Appl. No. : 10/766,179

DRAWING AMENDMENTS:

REMARKS

2/222

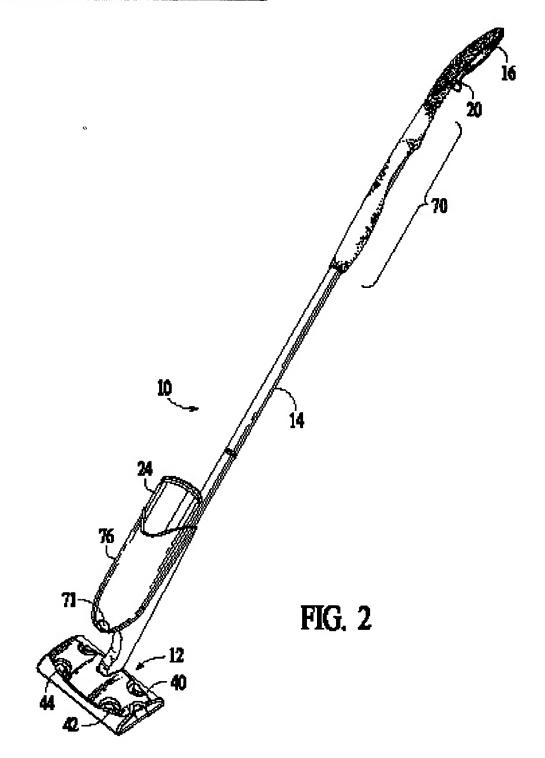
Applicants have amended page 2 of the drawings by replacing "2/222" with --2/22-- to address the objection raised by the Examiner.

FIG. 4

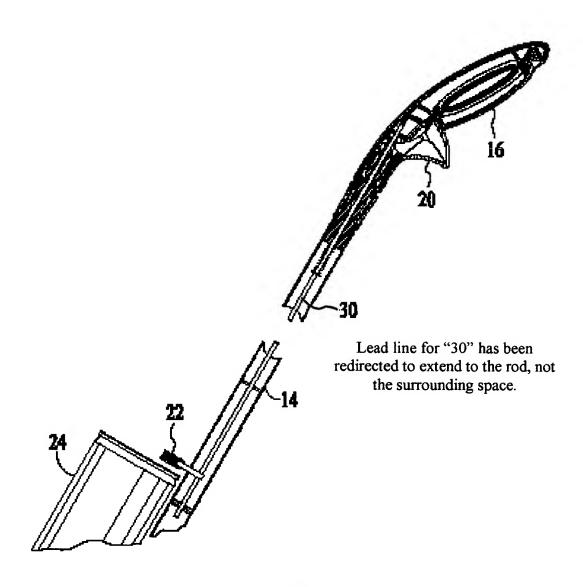
Applicants have amended the lead line for "30" on page 7 in Figure 4 to extend to the rod, not the surrounding space, to address the objection raised by the Examiner.
